PORSCHE

# **Service Information**

Technical Bulletins

January 1987 - December 1987

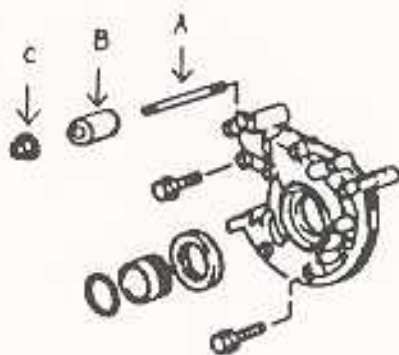
#### Modify the following: (Engines up to 1987)

To ensure proper fit of rear toothed belt cover in the area of the oil pump, grind or file cover material away until clearance is obtained.

Remove 10x45mm hex bolt at top of oil pump and install stud 944 102 216 01 (Arrow A) using Loctite 270. Place spacer (Arrow B) 944 107 911 00 over stud and install shouldered nut 944 102 243 00 (Arrow C) with collar facing oil pump and torque to 32.5 ft. lbs. (45 Nm).

Figure 1

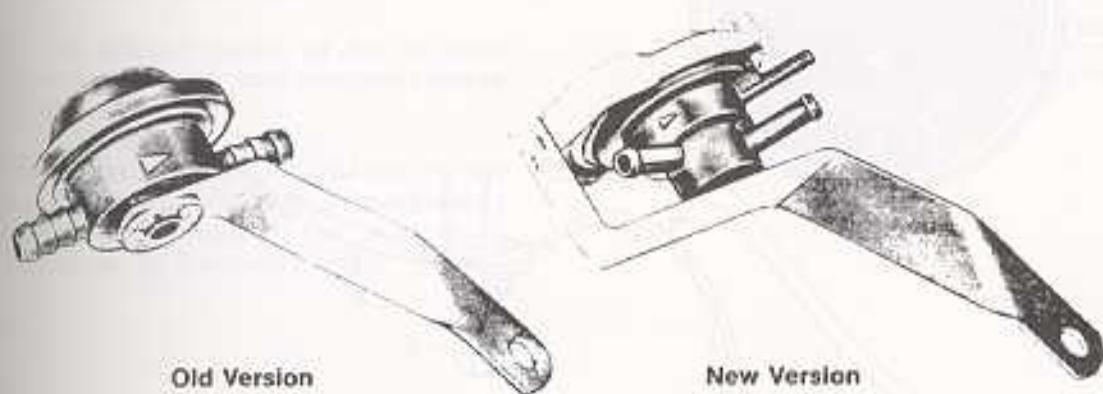
The ambient air valve for oil tank breathing and the mounting bracket have been modified to eliminate rattling noises.

Figure II

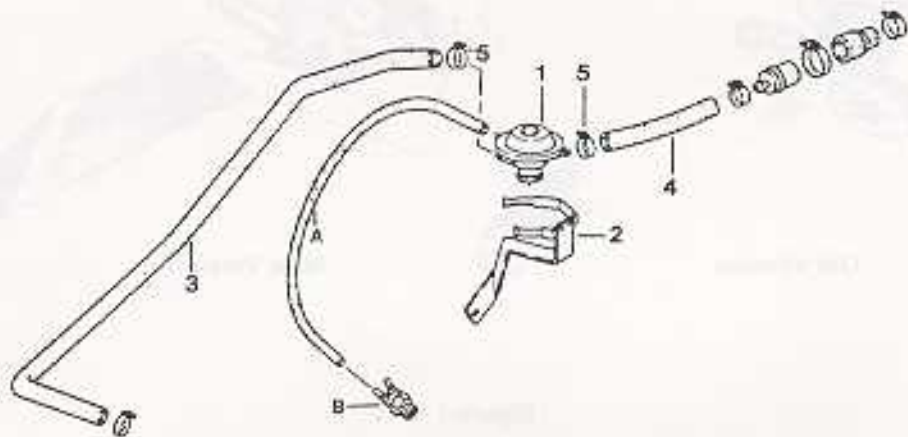
1. Remove air filter and air flow meter.
2. Remove bracket and air valve together with hoses (3 and 4 in Figure II). Pull off small hose (A in Figure II).
3. Mount new bracket.
4. Install new hoses (3 and 4) on air valve. Do not tighten clamps at this time. Connection for short hose (4) is marked with an arrow  on air valve. (See Figure I) Hose's diameter at air valve is 9mm (was 10mm).
5. Install air valve in clamping bracket. Install hoses on throttle valve housing and regulator valve and small hose on ambient air valve. Check hoses for proper routing. Do not kink hoses. Tighten all hose clamps.
6. Install air flow meter and air filter.

Incorrect vacuum hose connection on temperature switch (B in Figure II) can cause rattling noise. Angled connection of temperature switch connects to vacuum source and straight connection to air valve.

Subject: Improved Oil Cooler Mounting

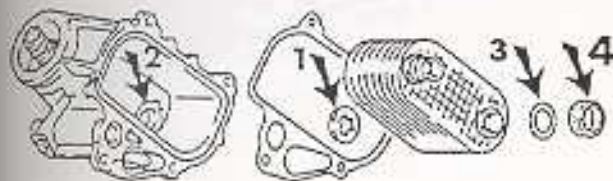
The oil cooler mounting was modified as follows:

1. Plastic washer installed between housing and oil cooler.
2. Housing - Guide drilling reworked.
3. Adjustment shims between cooler and crankcase installed.
4. Rubber ring - Always replace.

**Subject:** Radiator Thermostat  
Mounting Modified

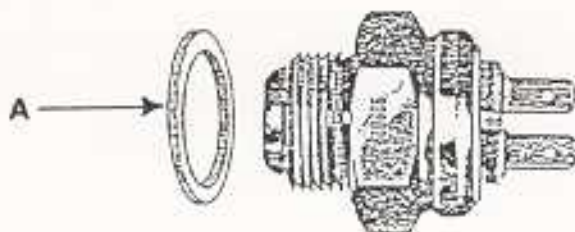
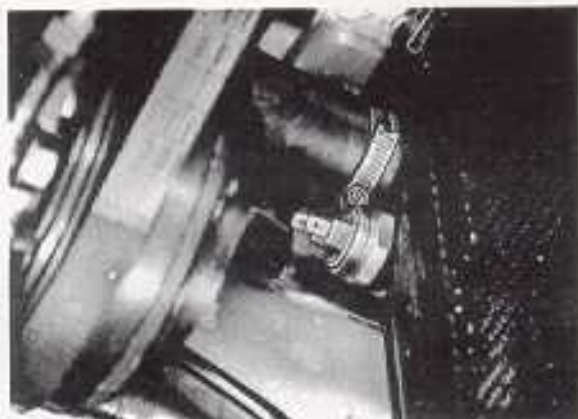
For model year '86 and '87, the thermostat in the radiator tank for the cooling fans can be mounted in one of two ways:

1. Thermostat into plastic threads or,
2. Thermostat into threaded brass insert.

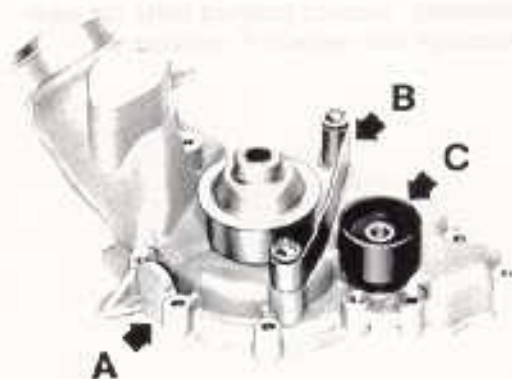
A new coolant pump is installed on all 4 cylinder engines since July 1986 beginning with the following engine numbers:

This new version pump has modifications to the seals and pump body in the area of the vent bore (Arrow A). In addition, a guard rail (Arrow B) is installed and the toothed belt roller (Arrow C) is offset to guide the toothed belt.

**Subject:** Installing New Type Coolant Pump

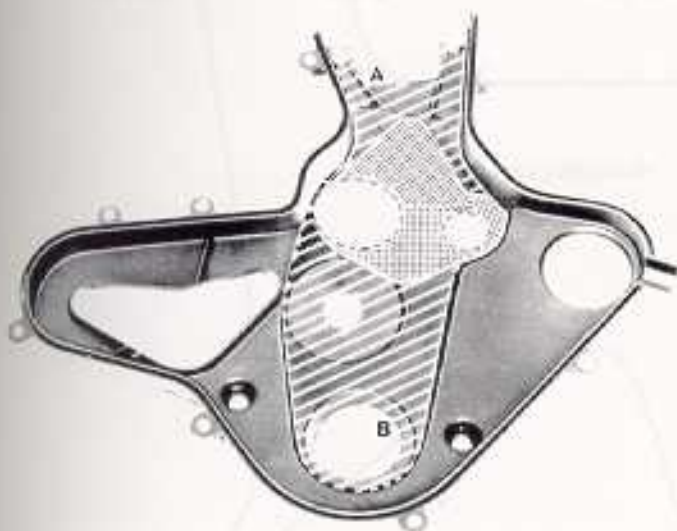
When installing the new type coolant pump on earlier engines, the rear toothed belt cover must be modified to conform with the larger roller and new guard rail. To accomplish this, place the supplied upper and lower template inside the rear toothed belt cover and mark the opening between them. This is the material to be removed. Remove the belt cover material by grinding or filing.

Subject: Oil Supply Lines  
For Chain Tensioner

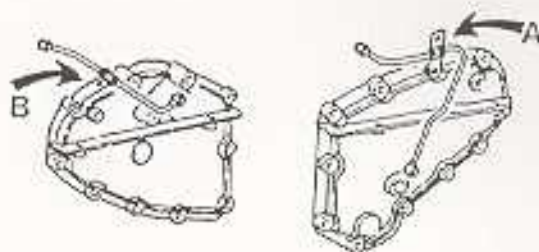
The right chain tensioner oil supply line was modified and the right and left oil supply lines are installed with an additional bracket on the chain housing cover. (Arrows in picture).

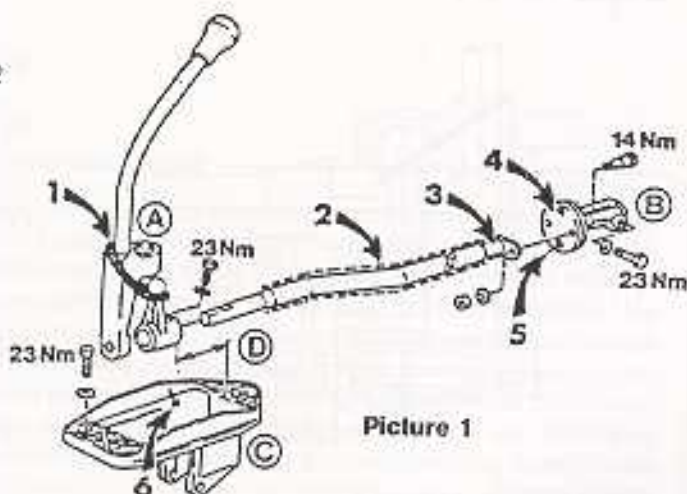
From Production Date: August 28, 1986

To convert 1987 model cars prior to the above vehicle identification numbers, the following parts are required:

Additionally the shift rod bushing (arrow in picture 2) inside diameter was reduced to 17.9mm (was 18.2mm)

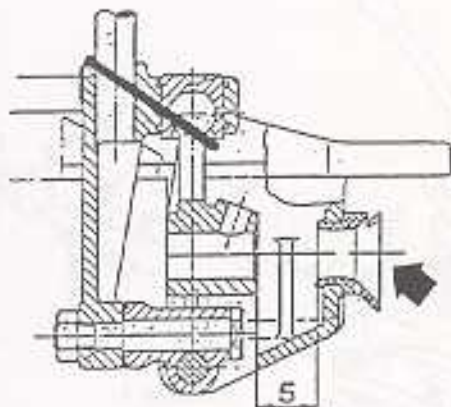
From Production Date: February 4, 1987

New Part Number: 950 424 224 03

This bushing can also be service installed. On cars built after August 28, 1986 but before February 4, 1987, it may only be necessary to replace this bushing.

**Subject:** Water Entering Car  
in Area of Taillights

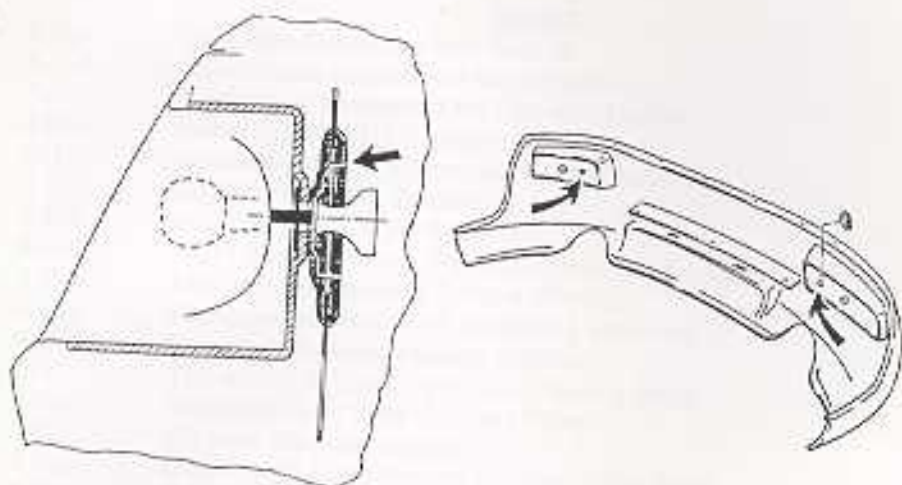
The foam rubber seal for the taillight screws was replaced with a plug-type grommet.
